## SECTION 00 91 11.03 - ADDENDUM 003

20250312 - BL017 STUDENT BUILDING  
(FRANCES MORGAN SWAIN) - F100  
ANTHROPOLOGY GEOGRAPHY LABS

A/E PROJECT 5-6672

### **2.1 SHEET A1.1.0 - GROUND FLOOR PLAN & DOOR SCHEDULE (REISSUED)**

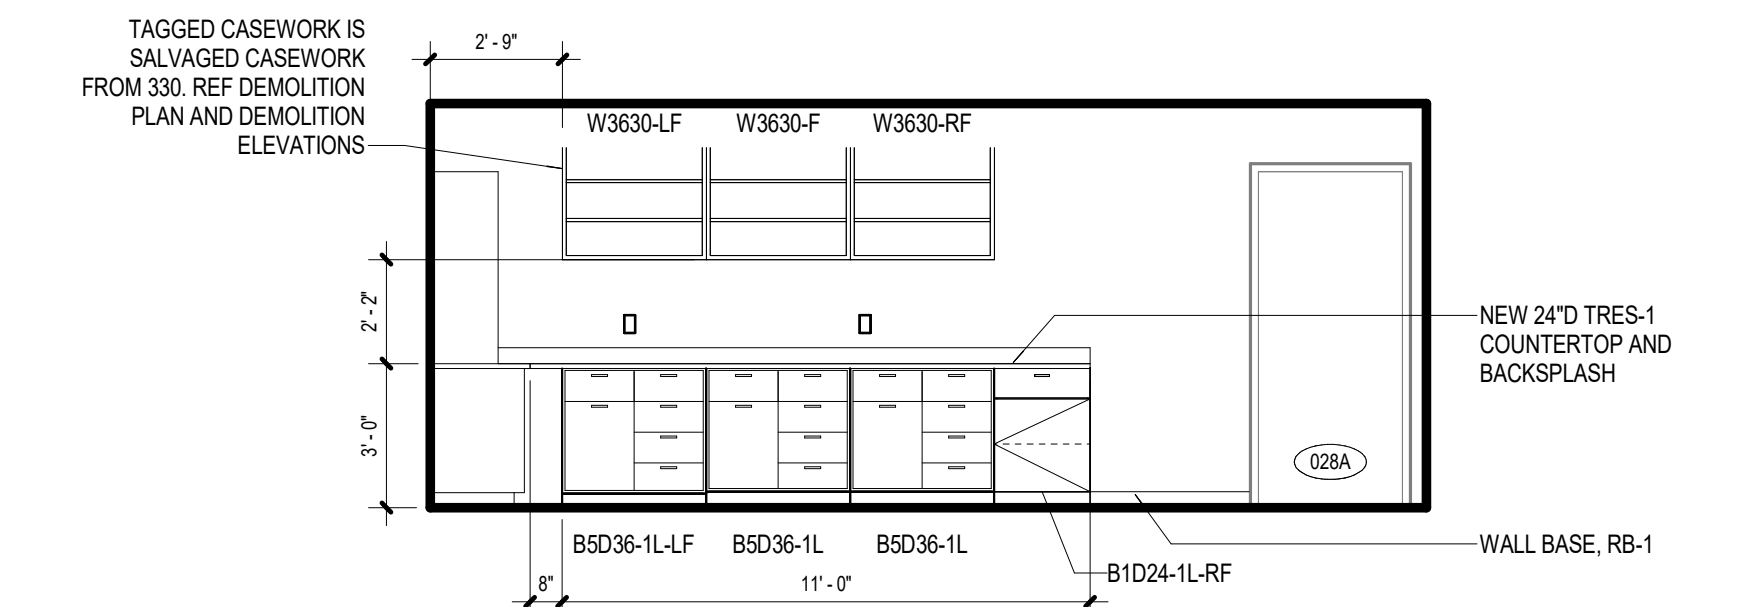
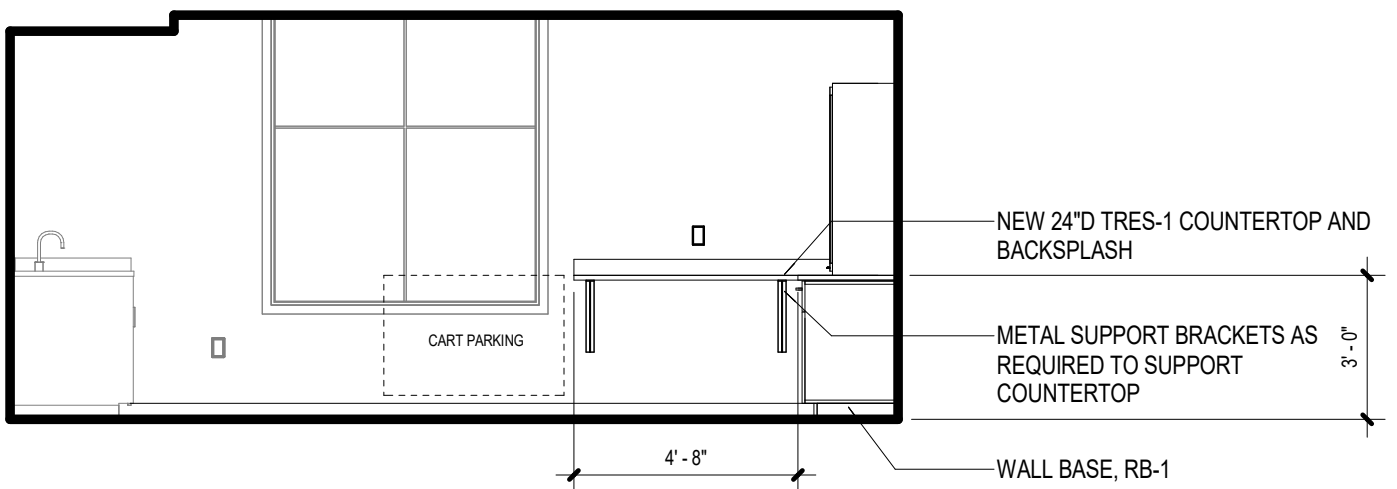
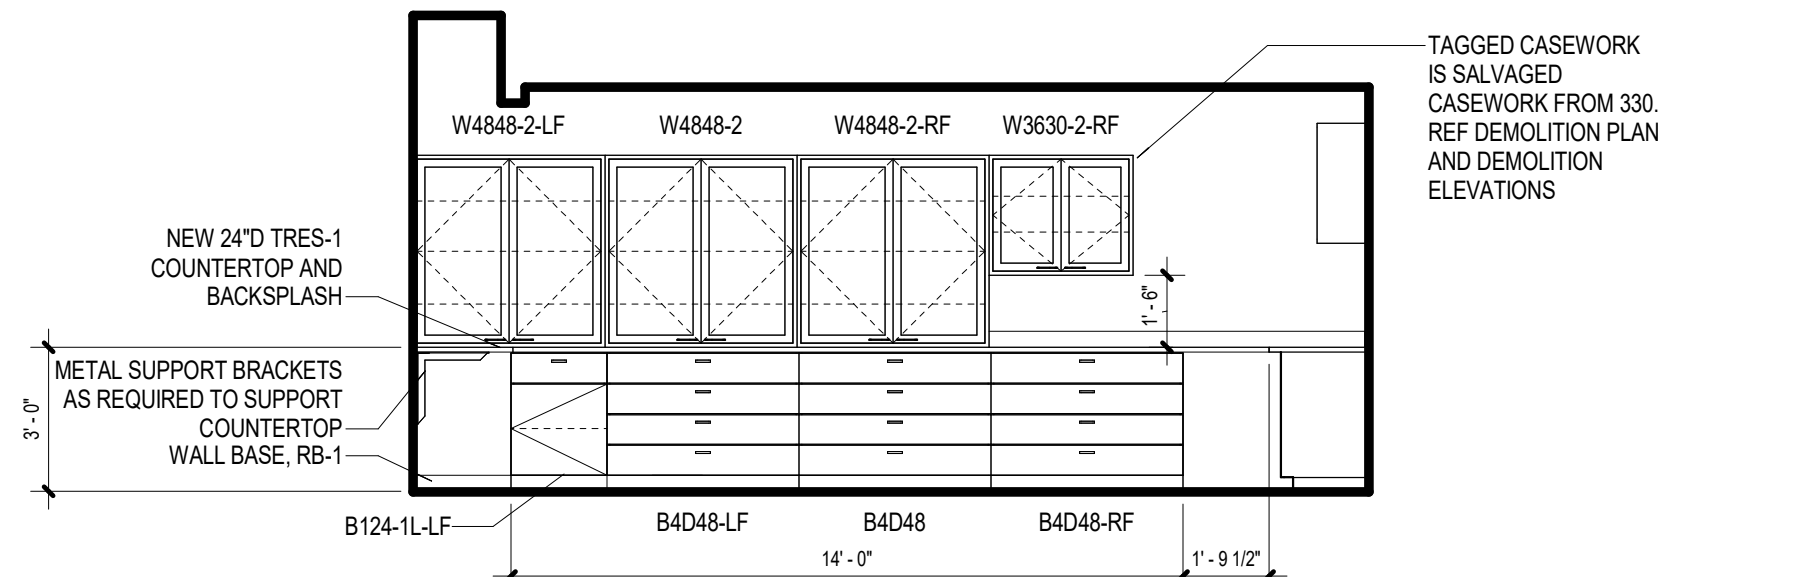
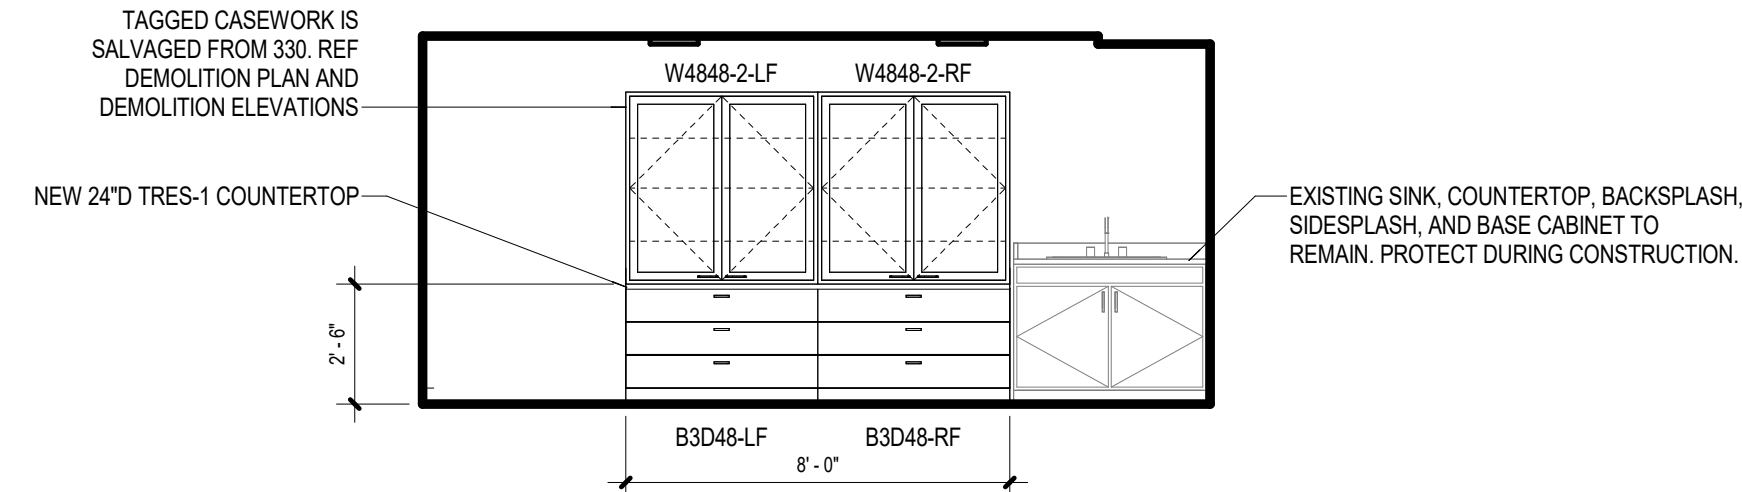
Q: Referencing Sheet A1.1.0 Elevations 1,2,3,4. Just want to confirm that the new TRES-1 countertops and backsplashes will be furnished and installed by the Owner's vendor?

A. Note clarified for who provides countertops in Dry Lab 028

A: The TRES-1 countertops and backsplashes on A1.1.0 are by GC. They are associated with the salvaged casework that is by GC; therefore the GC is to provide the countertops here. Spaces with all new casework has casework by the Owner's vendor.
